PROPOSED DUNBARTON ROAD GATE PLAN

PL-ADM-2026-0144 administratively approved for the noted security gate installations on June 2, 2026 with the following conditions:

PROPOSED RECTORY ROAD GATE PLAN

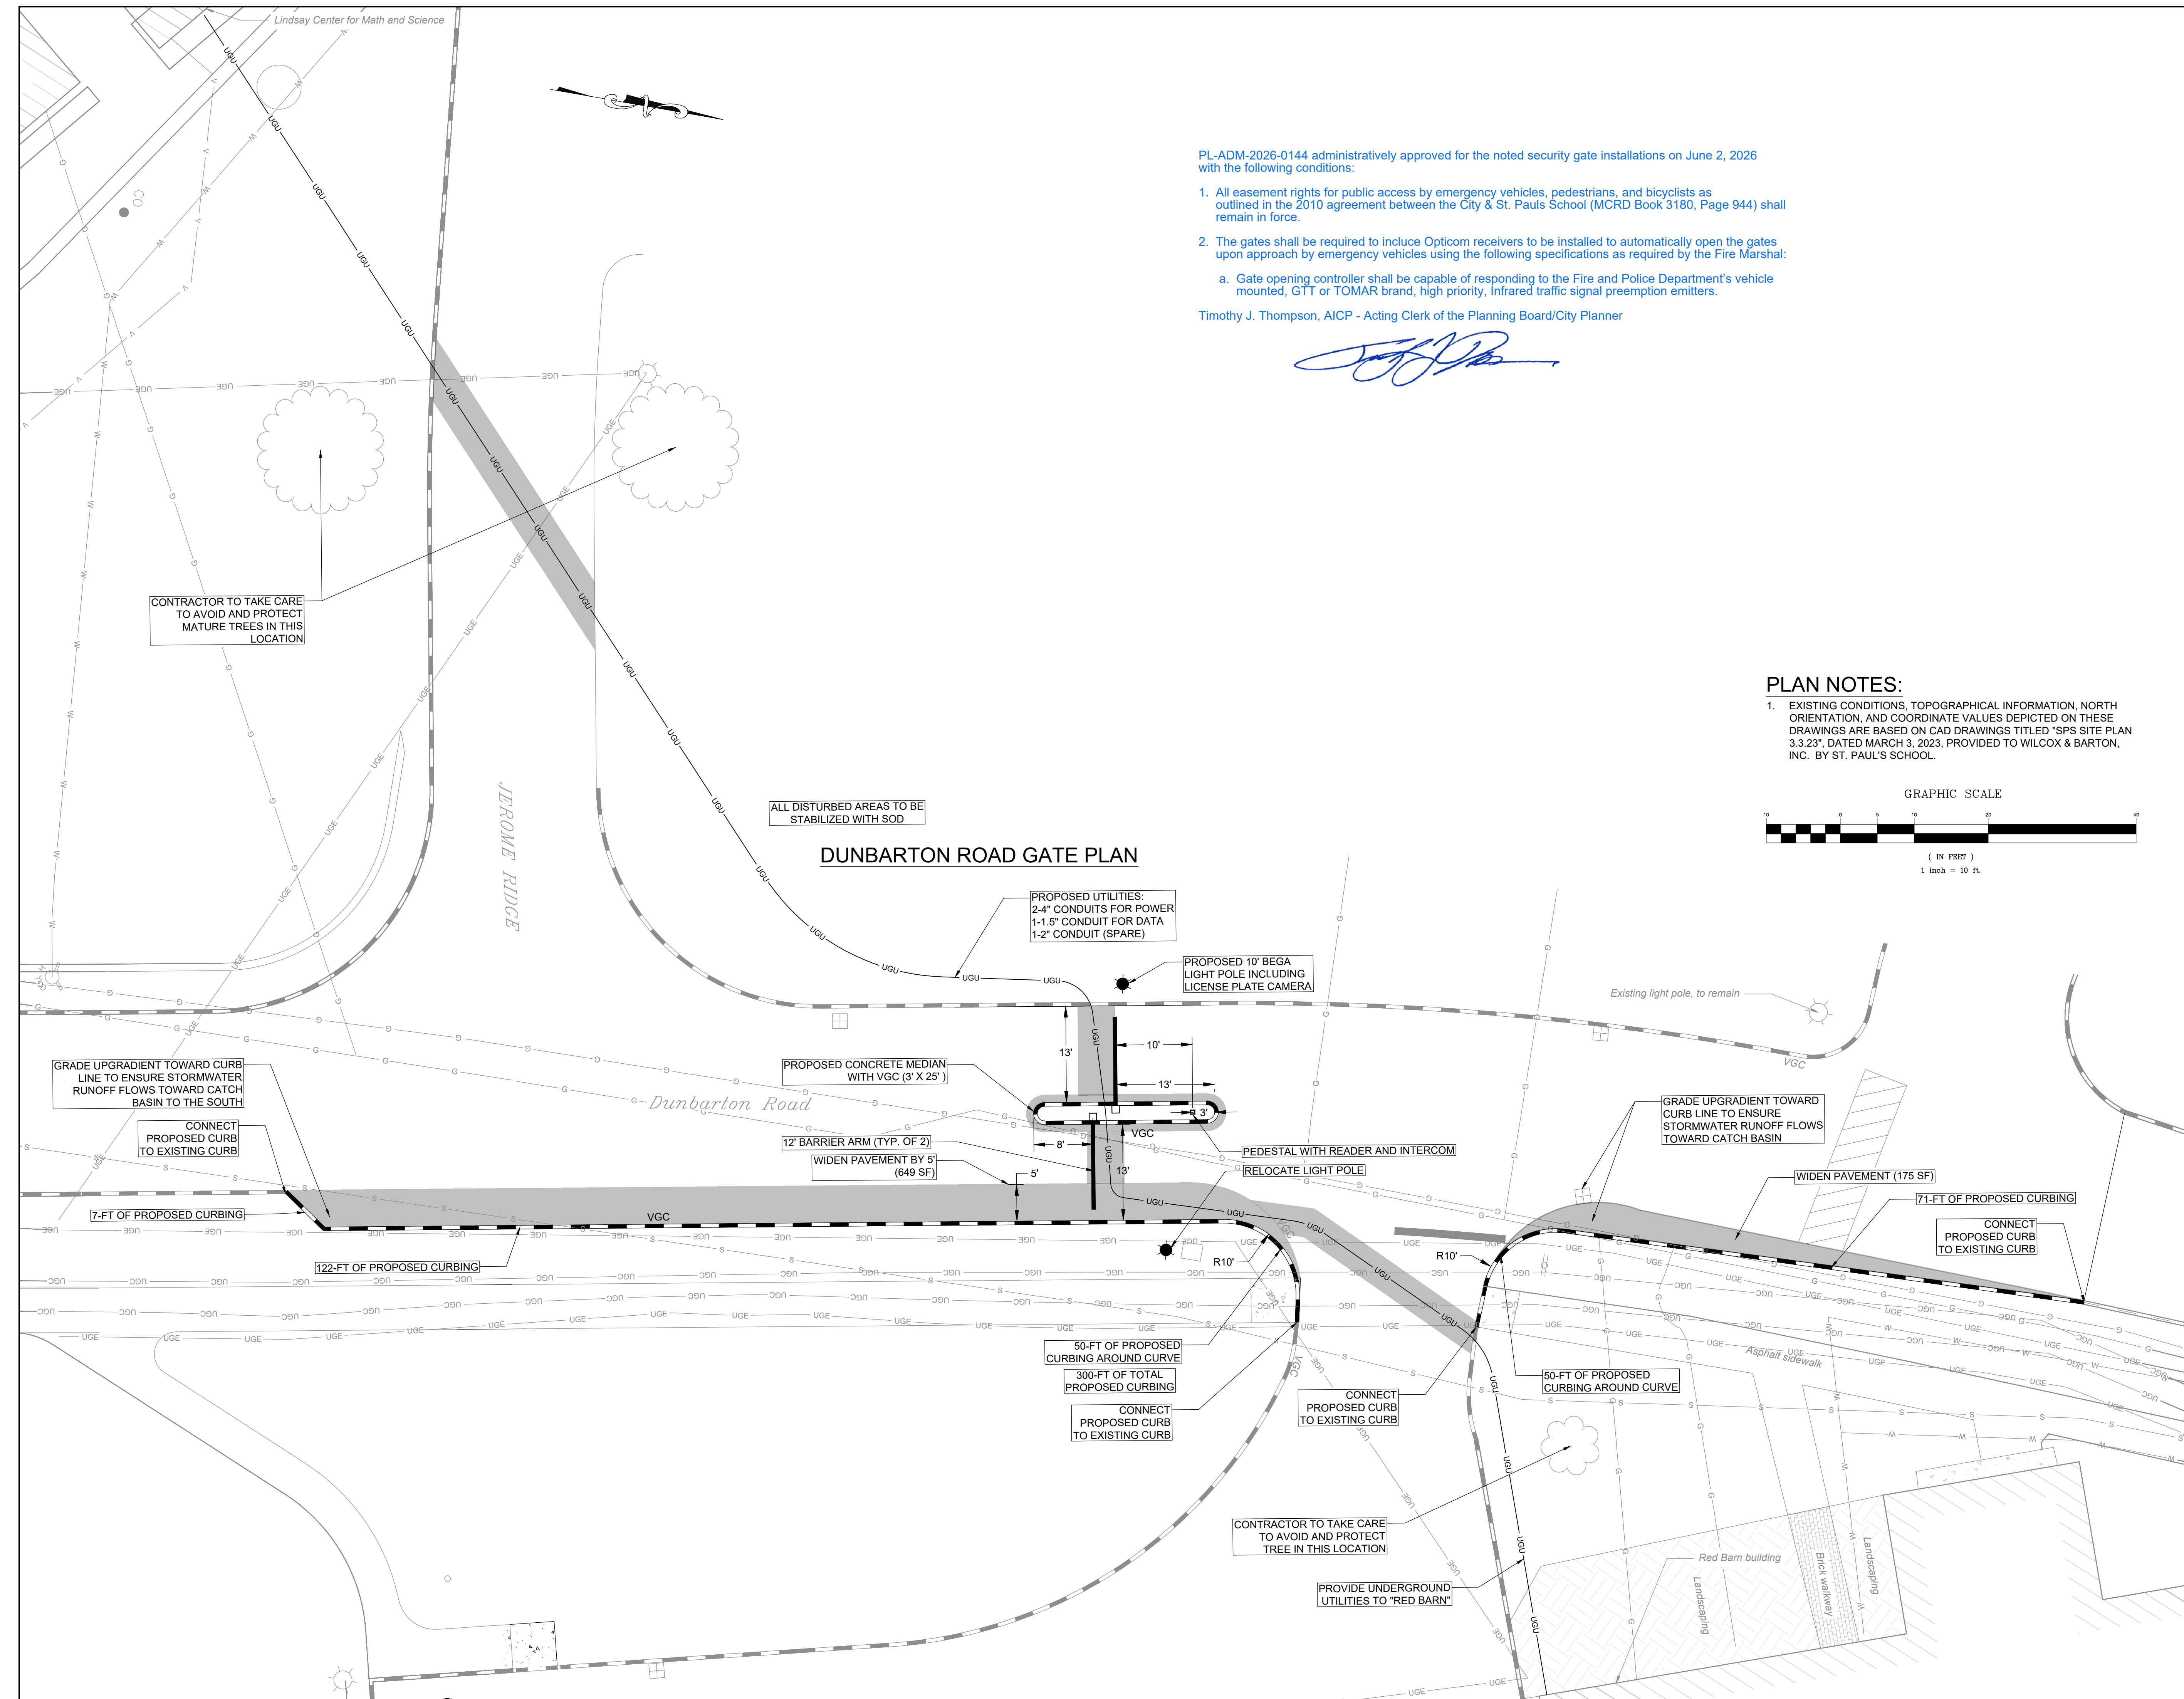
- All easement rights for public access by emergency vehicles, pedestrians, and bicyclists as outlined in the 2010 agreement between the City & St. Pauls School (MCRD Book 3180, Page 944) shall remain in force.
- The gates shall be required to include Opticom receivers to be installed to automatically open the gates upon approach by emergency vehicles using the following specifications as required by the Fire Marshal:
 - Gate opening controller shall be capable of responding to the Fire and Police Department's vehicle mounted, GTT or TOMAR brand, high priority, infrared traffic signal preemption emitters.
